City of Portland, Oregon
Bureau of Development Services
Land Use Services

NOTICE OF A TYPE II DECISION ON A PROPOSAL IN YOUR NEIGHBORHOOD

CASE FILE NUMBER: LU 12-118607 DZM –ELIOT-MLK APARTMENTS

12-118607 D2M
EX. C-1

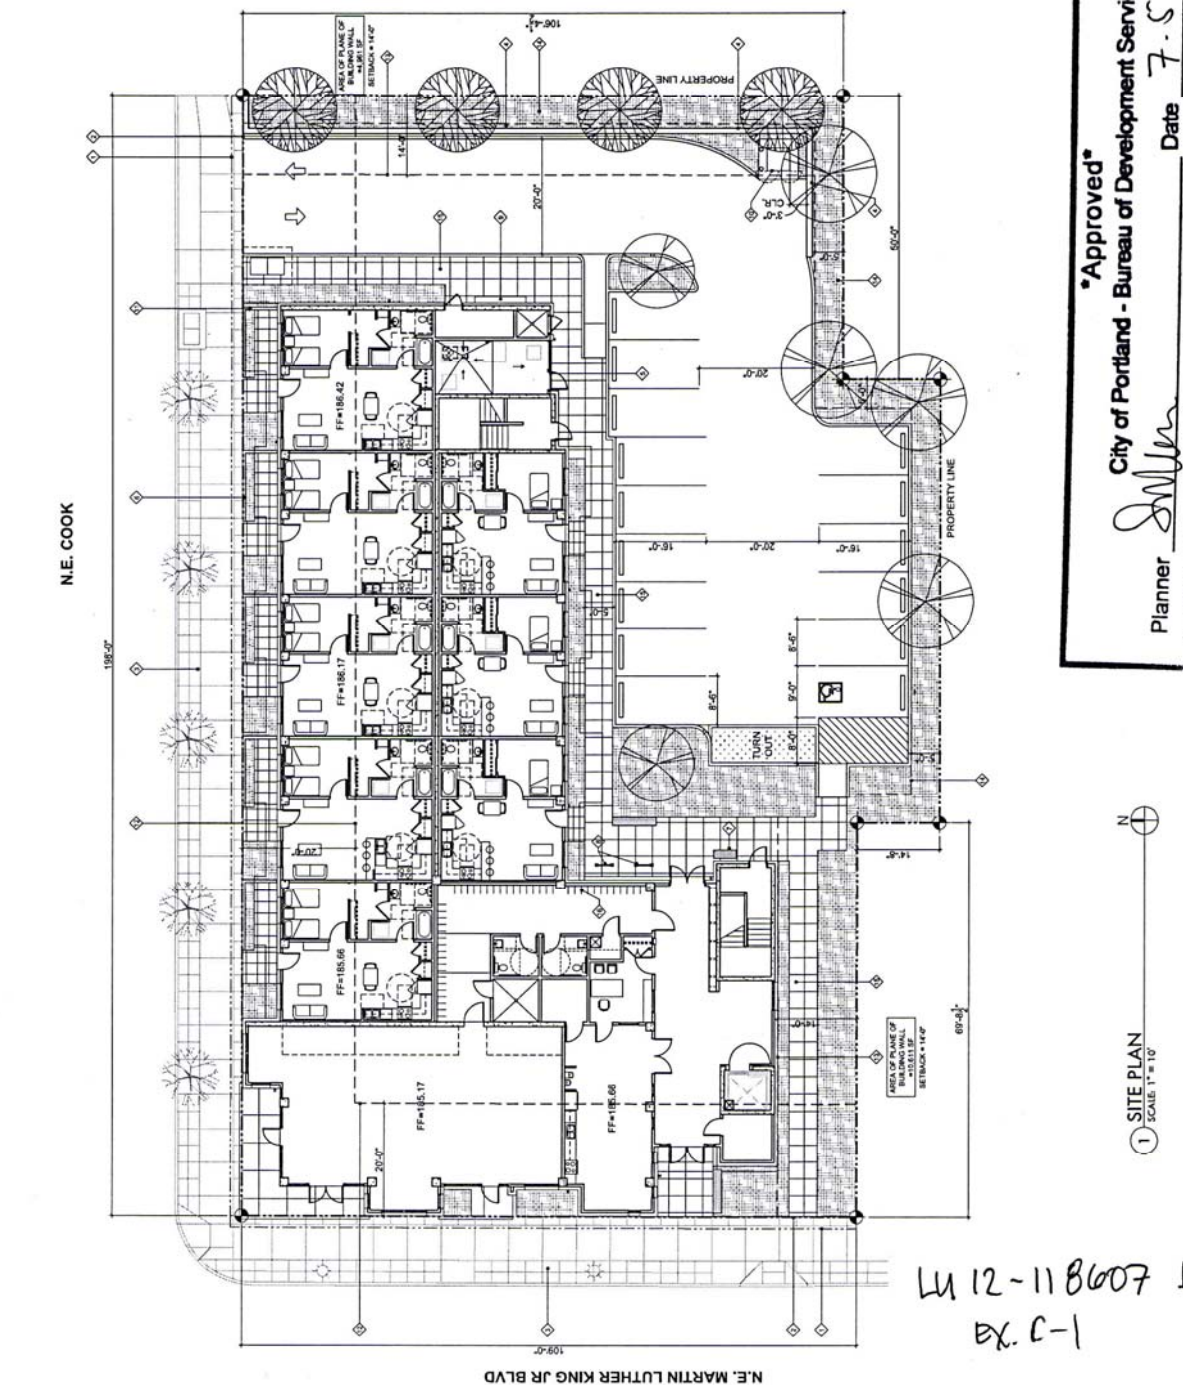
Modification: Section 33.505.100.C.4.b requires that access must be from a local service traffic street (Cook) which is within 150 feet of the intersection with an arterial (MLK). The applicant proposes to locate the access 171 feet from the intersection, exceeding the limitation by approximately 21 ft.

Findings: The modification to locate the driveway 171 ft. rather than 150 ft. from the intersection of NE MLK Jr. Boulevard and NE Cook allows the driveway to be placed to the east of the building and provide more building than vehicle area linear frontage. This

distance supports design guidelines regarding E3 (The Sidewalk Level of Buildings), E4 (Corners that Build Active Intersections) and D4 (Parking Areas and Garages). *Therefore, this approval criterion is met.*

Approval of a Modification to exceed the 150'-0" maximum distance for access to parking from the intersection NE MLK Boulevard by 21'-0" (Section 33.505.100.C.4.b).

- B. This Design Review Approval is contingent upon the approval of three Property Line Adjustments (12-141865 PR, 12-141865 PR and 12-149846 PR) required for the proposed site configuration, as indicated on Exhibit C-1.
